SUBJECT: PARCEL 117 CRITICAL SITE REDEVELOPMENT SNAIL ERADICATION
PROJECT NO. 101690.01
PROCUREMENT NO. 022026-1019

ADDENDUM NUMBER 01

PARCEL 117 CRITICAL SITE REDEVELOPMENT
SNAIL ERADICATION
SITE PROFILES

05 ECOLOGY BLOCK WALL CROSS SECTION
SCALE: N.T.S.

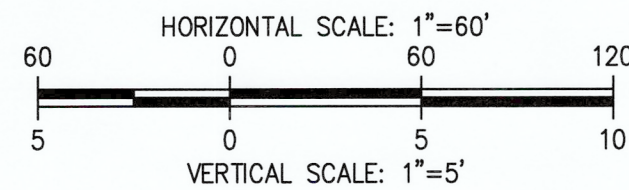
- 1. **Drawing C2.02** – In Detail 05, the “CSBC” note has been corrected to read CSTC.
